Impacts Caused by Excessive Clearing of Vegetation on Sloped Areas

Slope Map Showing Approximate Breakdown of Slopes by Percentage

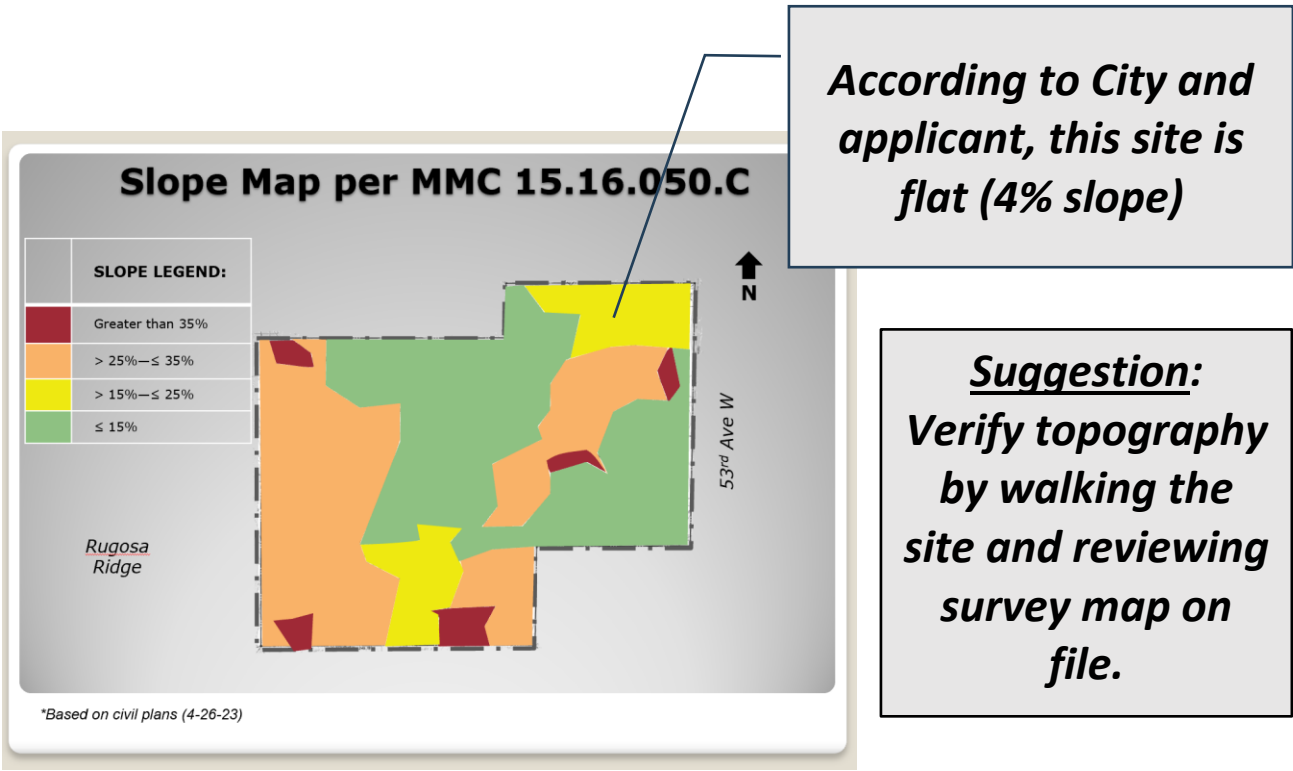
To meet the standards in Table 1 – Clearing Matrix, the application on file should have included a map showing a breakdown of on-site slopes according to steepness. Such a

map can be prepared easily using Autocad or other common engineering software. See the slope map below, which shows the site to be anything but flat...

AVERAGE SLOPE CALCULATION

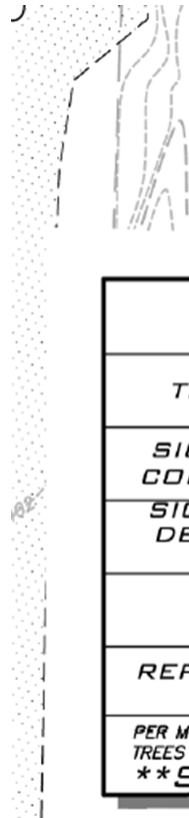
The chart in the email from Brian Wirt (below) shows the Applicant's method of calculating the slope of the property for the purpose of determining how many trees must be retained under 15.16.050.C. This calculation is incorrect. It does not address the requirements in Table 1. It reduces the complex topography of the property down to a single number: "**4% Average Grade.**" The resulting calculation of the number of trees that must be retained is incorrect since the slopes are not broken down by category of steepness as required by code. In the applicant's calculations, there is no mention of the maximum amount of native vegetation removed, also required by Table 1.
